ATTACHMENT 2

Markup of Technical Specification Pages

Figure 3.4.11-1 (Page 1 of 1)
Unit 1
P-T Curves for Hydrostatic or Leak Testing up to 32 EPY

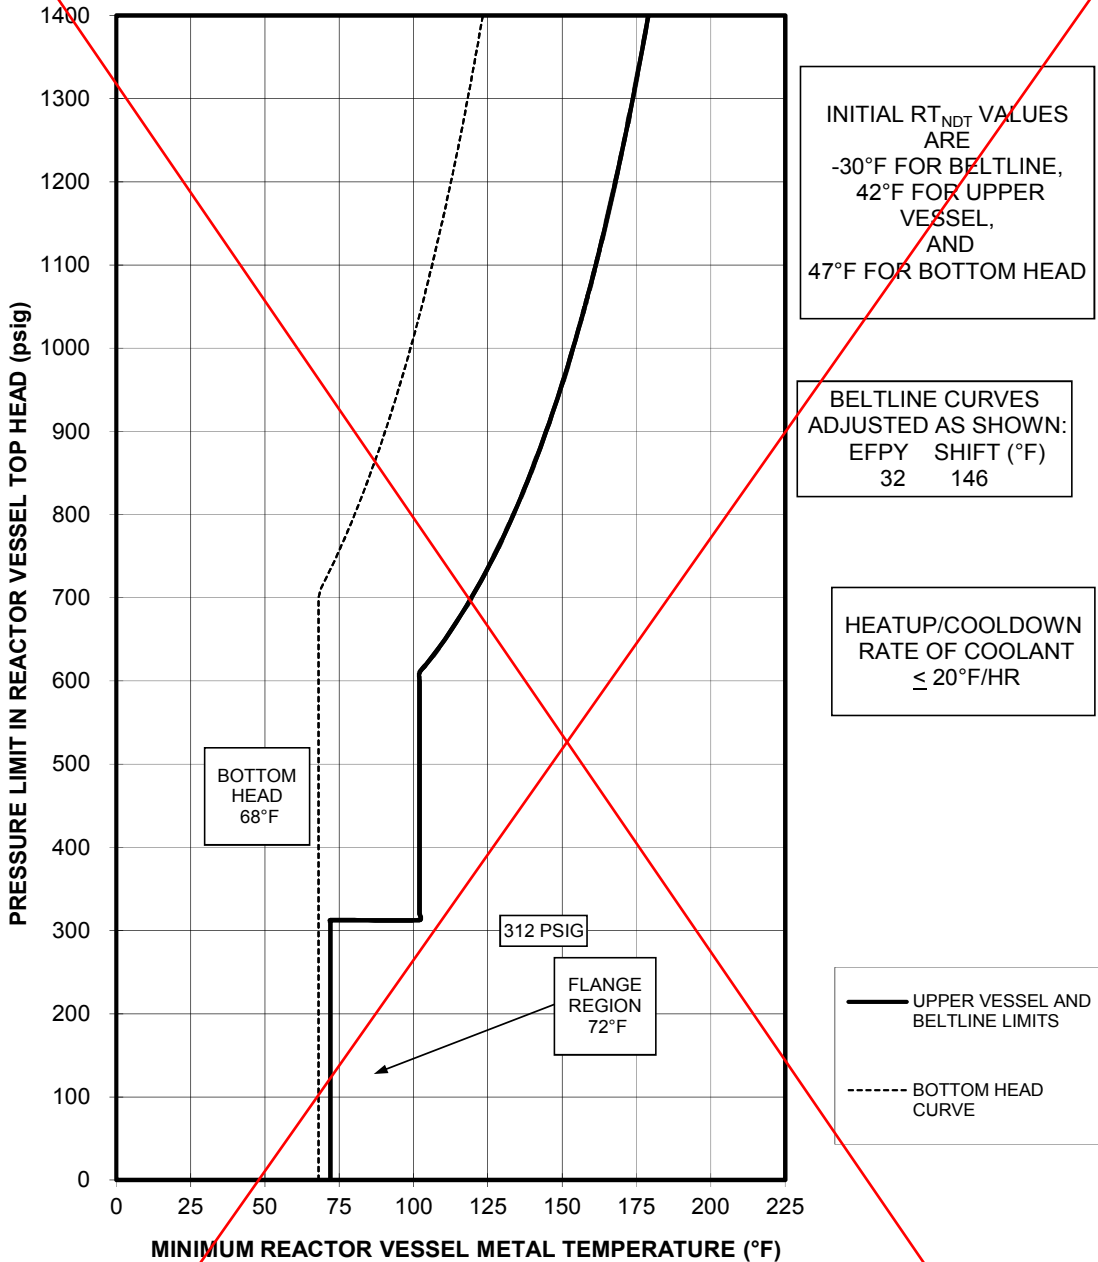
INFORMATION CONTAINED ON THIS PAGE HAS BEEN DELETED

Figure 3.4.11-2 (Page 1 of 1)
Unit 1

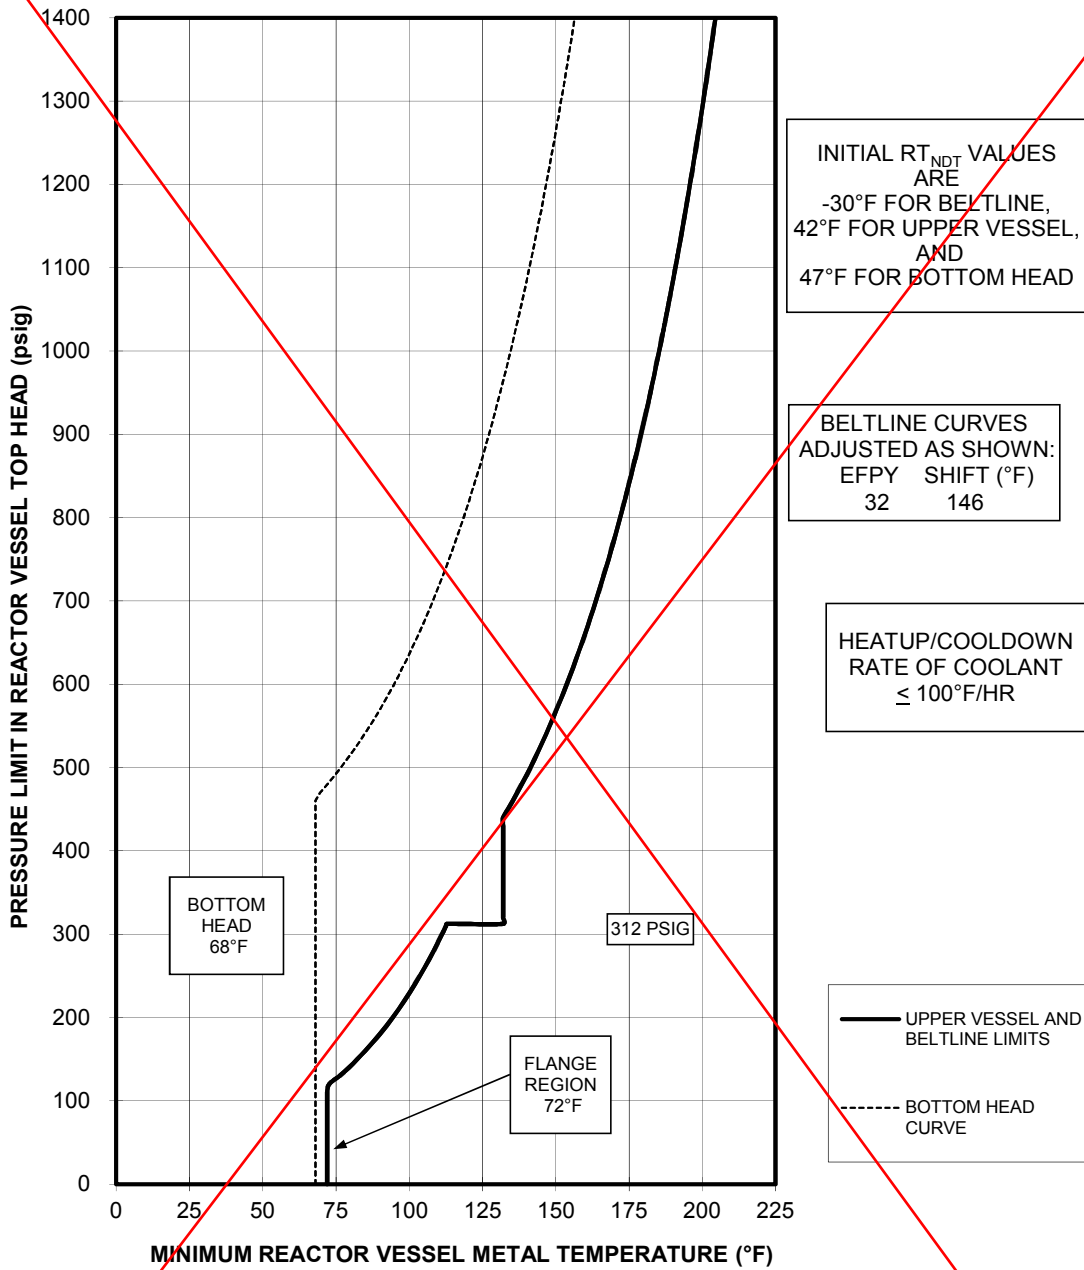
INFORMATION CONTAINED ON THIS PAGE HAS BEEN DELETED

Figure 3.4.11-3 (Page 1 of 1)
Unit 1
P-T Curves for Operation with a Core Critical
other than Low Power Physics Testing up to 32 EFPY

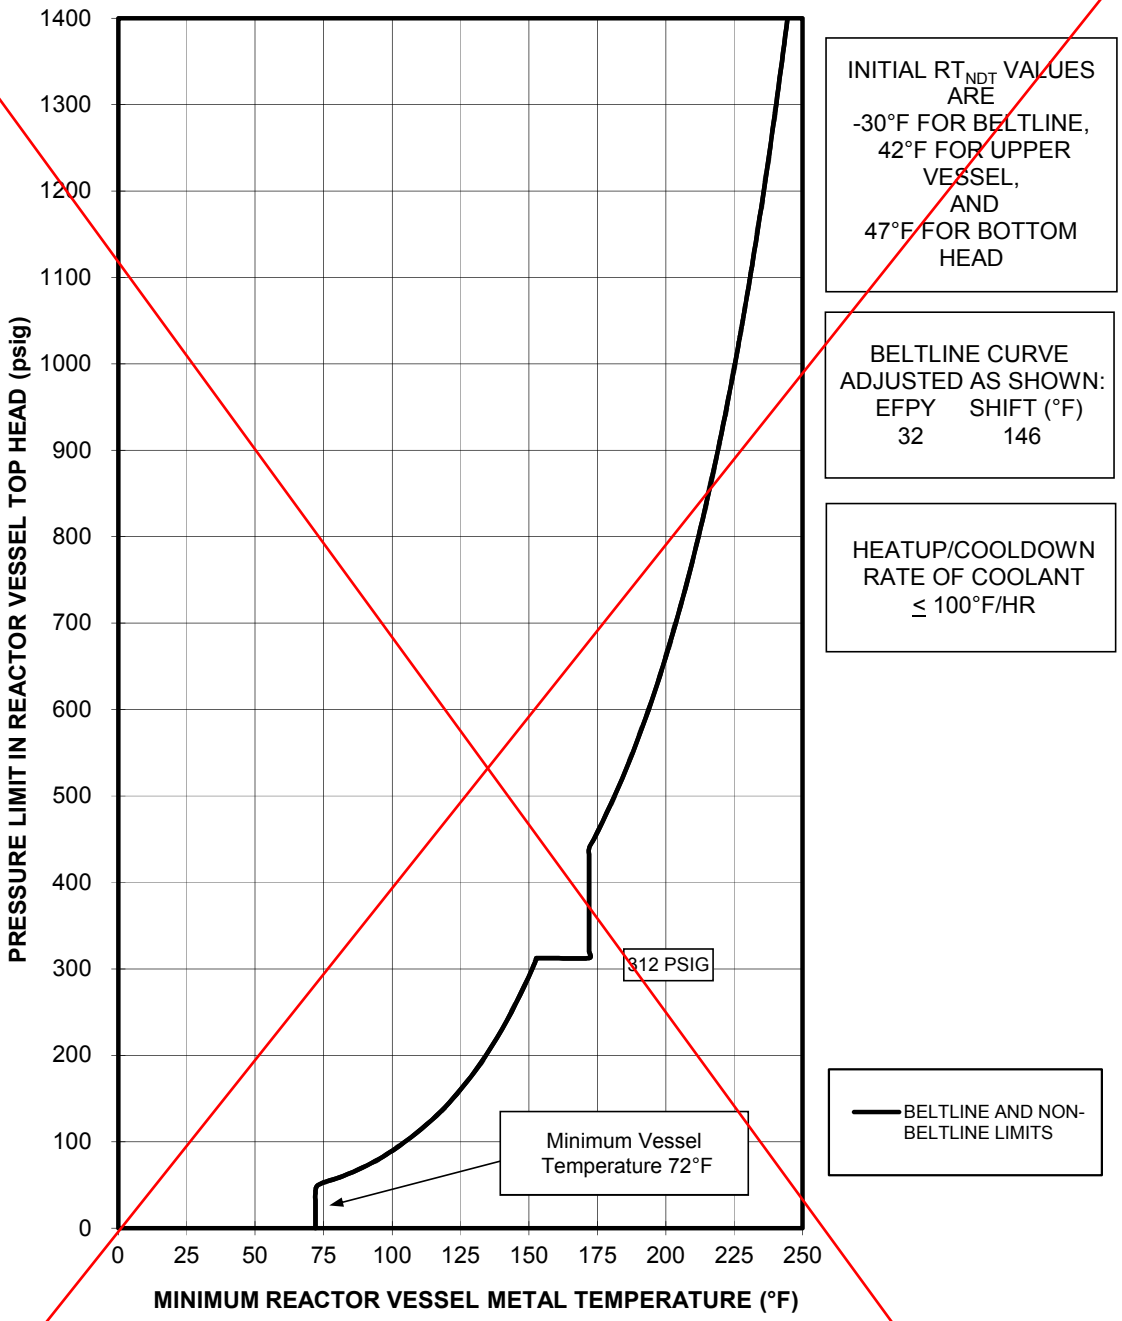
INFORMATION CONTAINED ON THIS PAGE HAS BEEN DELETED

Figure 3.4.11-4 (Page 1 of 1)
Unit 2
P-T Curves for Hydrostatic or Leak Testing up to 32 EPFY

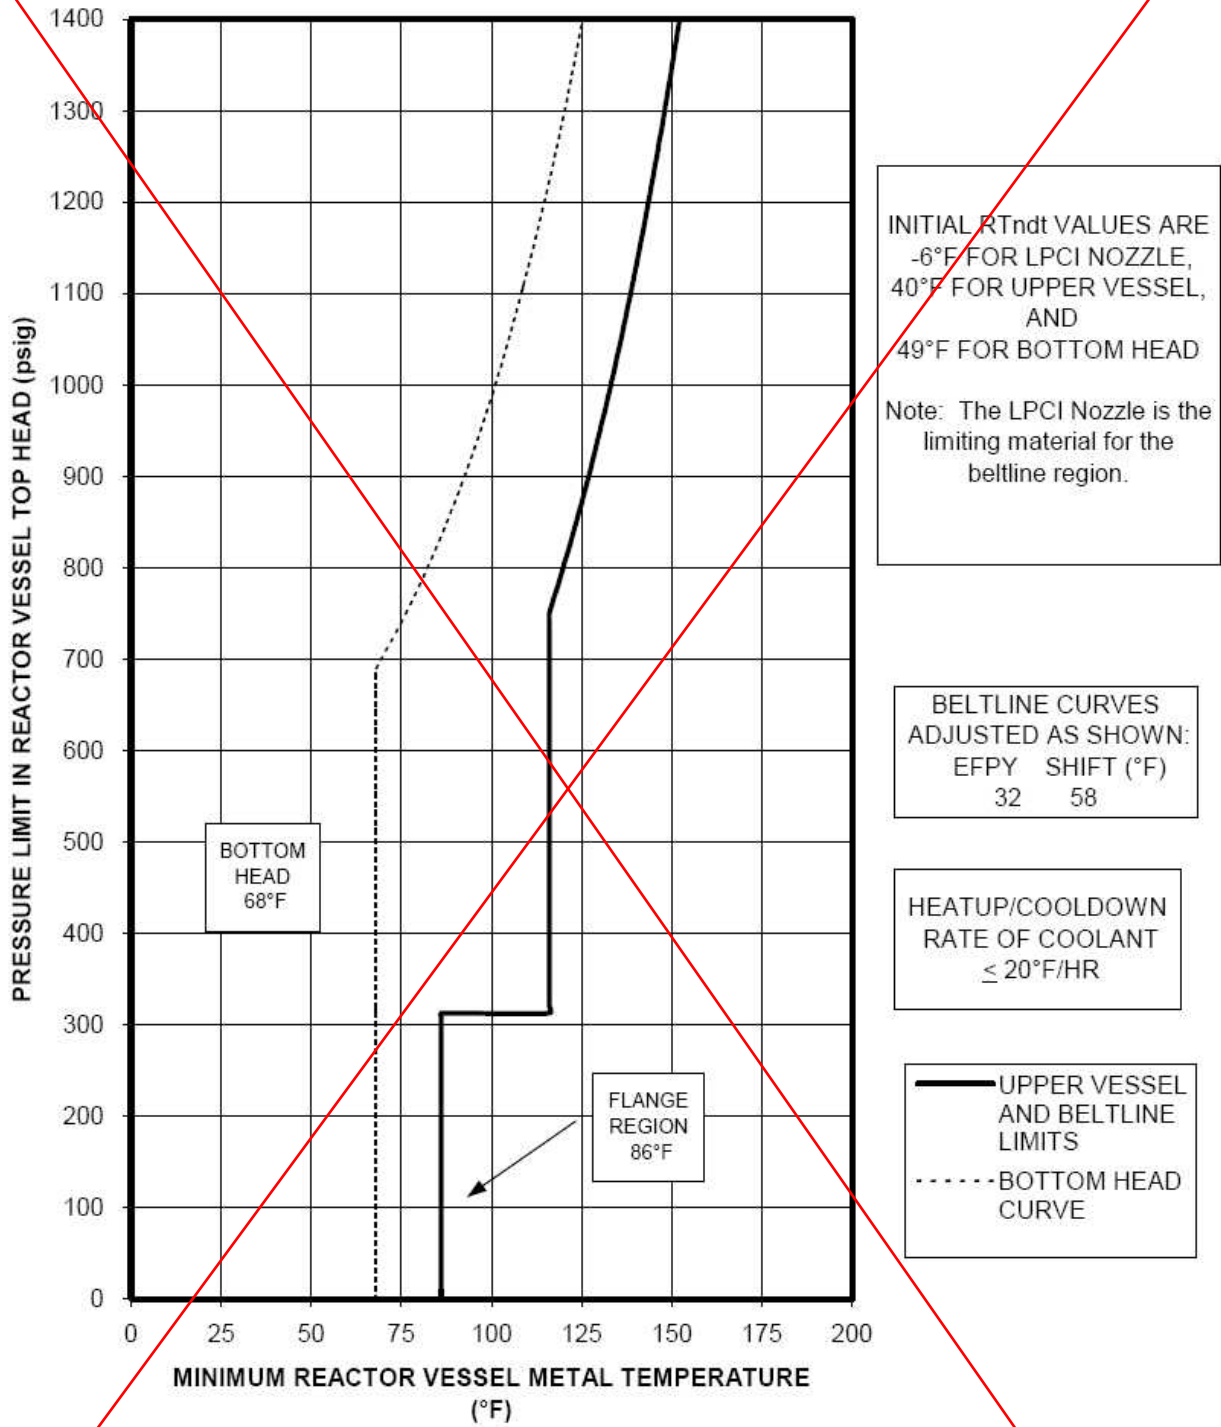
INFORMATION CONTAINED ON THIS PAGE HAS BEEN DELETED

Figure 3.4.11-5 (Page 1 of 1)
Unit 2

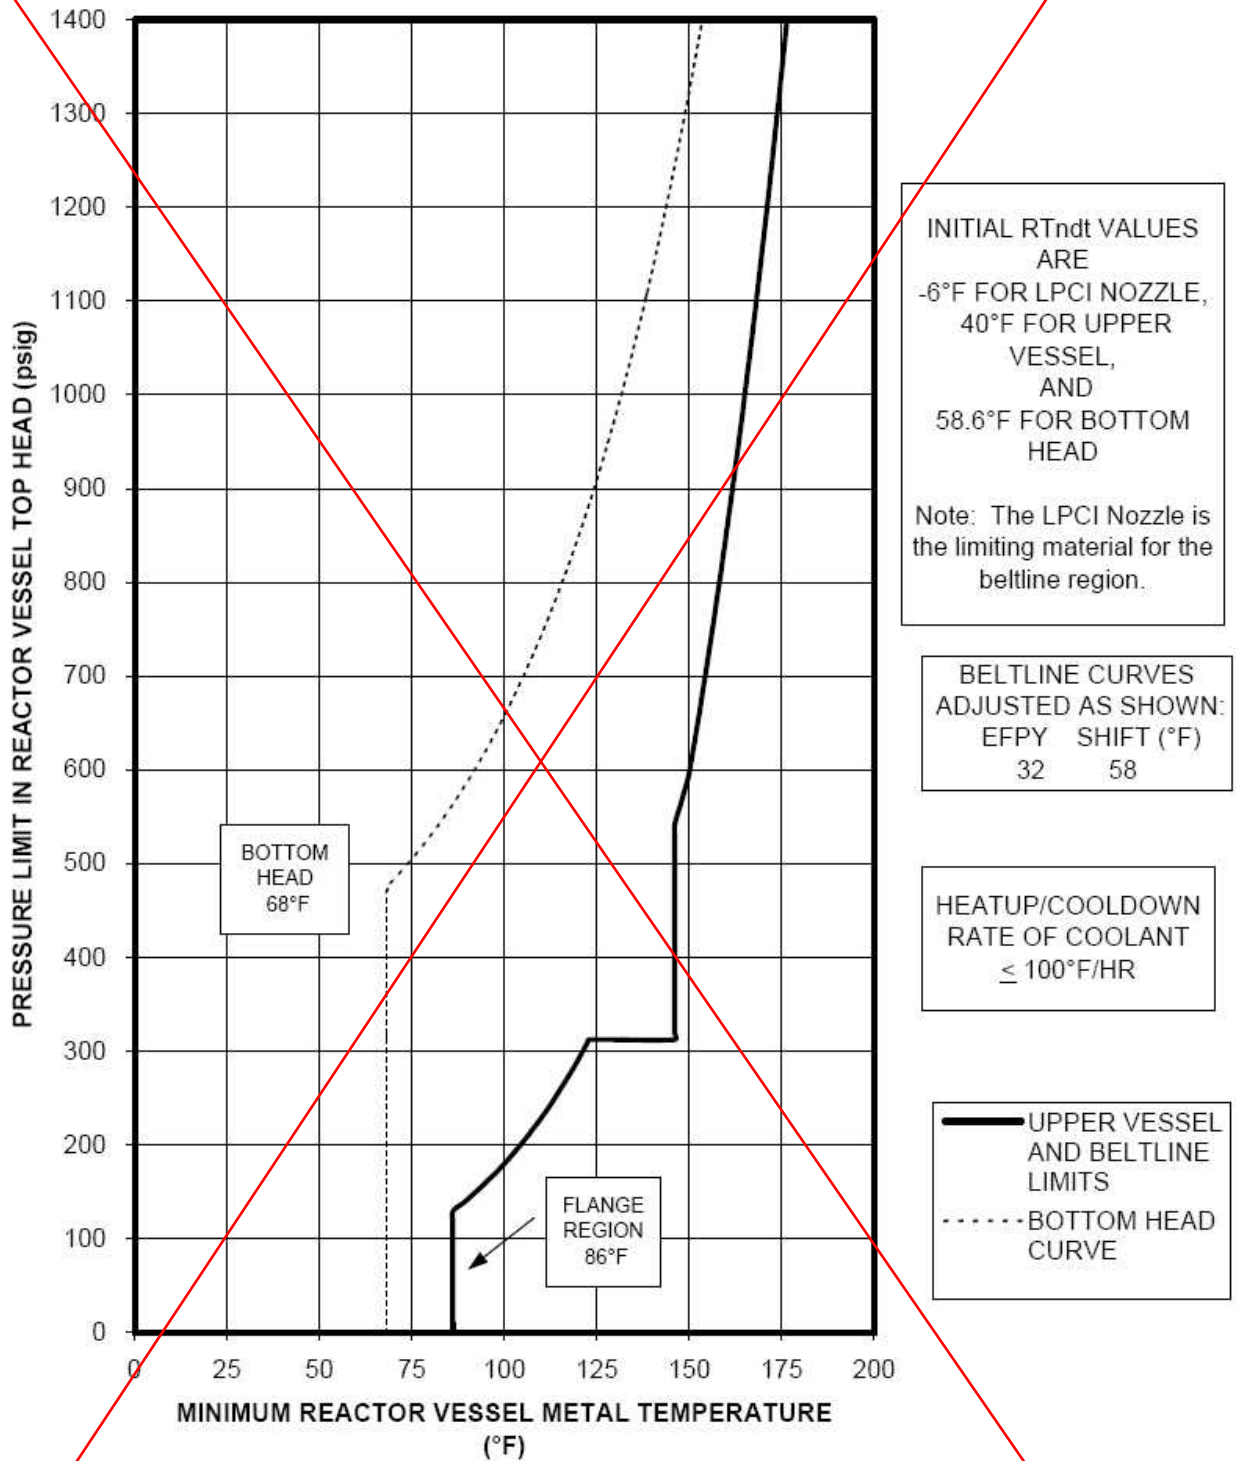
INFORMATION CONTAINED ON THIS PAGE HAS BEEN DELETED

Figure 3.4.11-6 (Page 1 of 1)
Unit 2
P-T Curves for Operation with a Core Critical
other than Low Power Physics Testing up to 32 EFPY

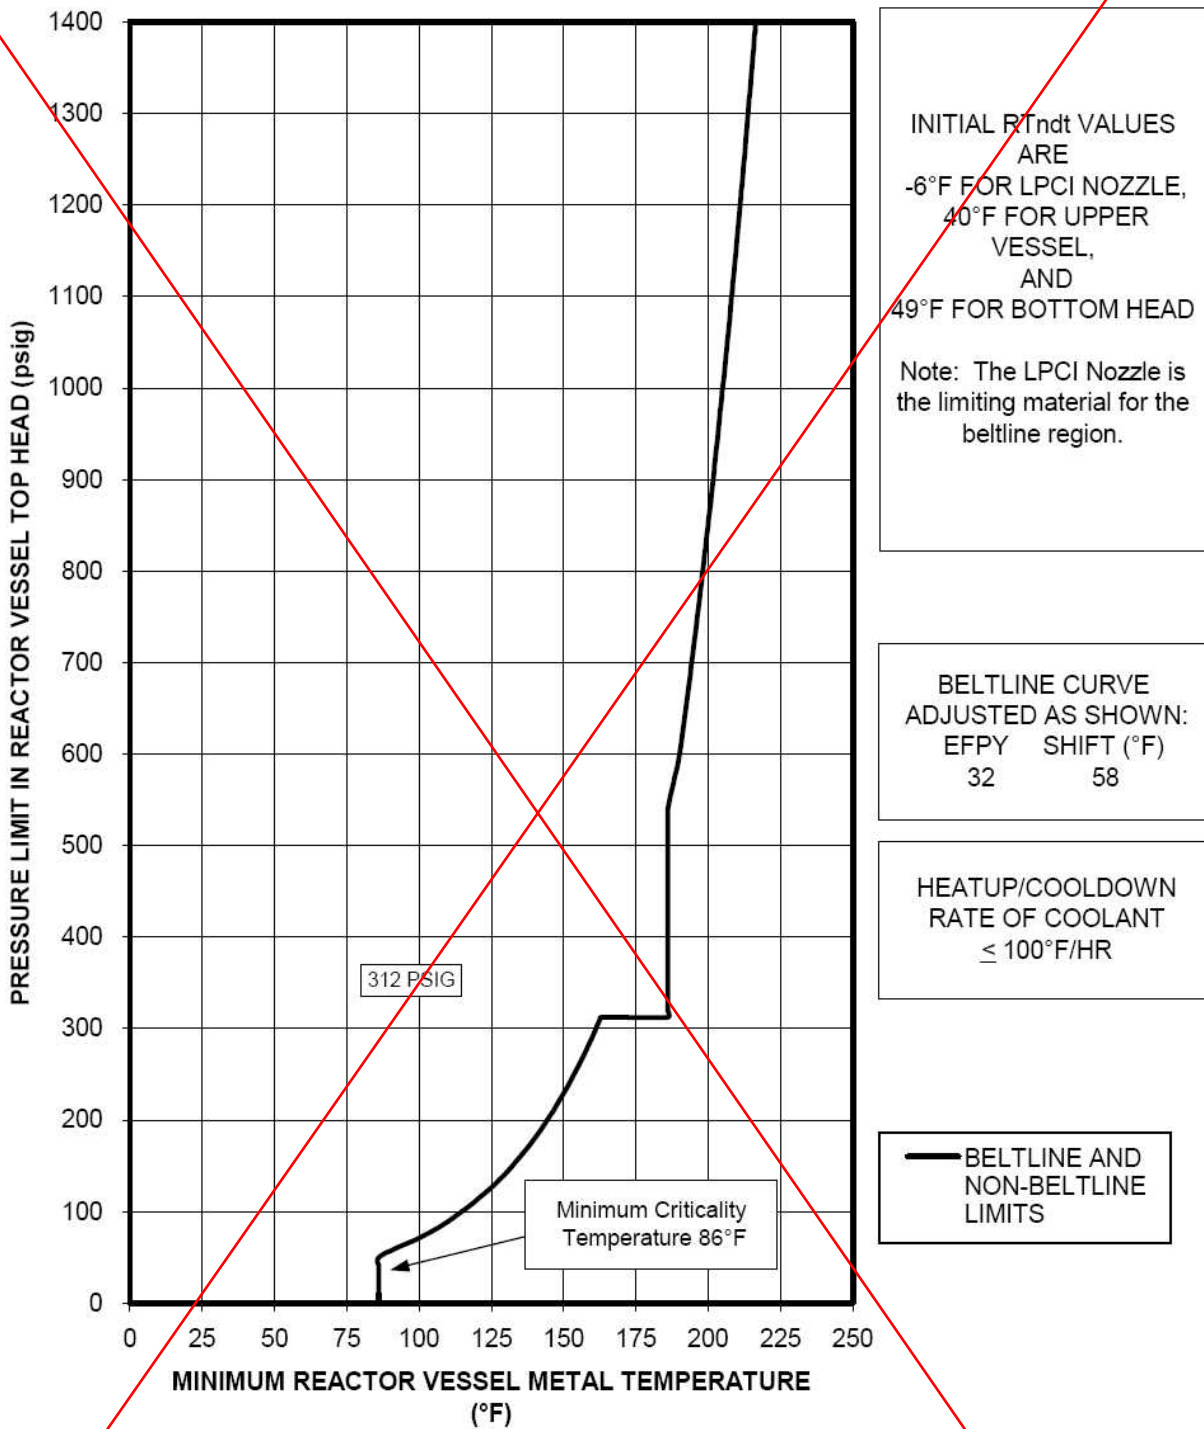
INFORMATION CONTAINED ON THIS PAGE HAS BEEN DELETED
